## CITY OF VANCOUVER

### POLICY REPORT DEVELOPMENT AND BUILDING

SUBJECT: CD-1 Rezoning – 3200 West 41st Avenue (Crofton House School)

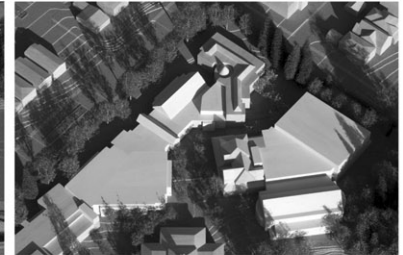
- concern was noted over the expression of the senior school and its potential to be overly drastic;
- concern was expressed relative to the continuous building form on West 41st Avenue;

- the senior building on West 41st Avenue could use some breaking up and differentiation at the scale of the other buildings;
- one member disagreed with the concern of the long building form that was connecting the Bryan Hall to the Fine Arts Centre, and noted that the roof form was more important than whether or not the building was long; additionally it was noted that texture and articulation were relevant;

- the gym would be the most contentious in its currently proposed setback and form; more conceptual options could have been presented;
- the gym needed consideration with respect to how it was brought to the street;

- some concern was expressed relative to the gym volume as perceived from the street;
- the form and development and resulting inside spaces and courtyards were quite nice;

- (ii) design development to the scale of the Senior School;

Note to Applicant: Provide more articulation to massing so it is less undifferentiated and continuous in form.

- (iv) design development to the gymnasium's height, linkages to the heritage building and scale as it presents itself to the street;

Note to Applicant: Linkages between the buildings need to be sensitively handled, providing for transitions in height, massing and materials that minimize impact on heritage resources. Provide for greater articulation
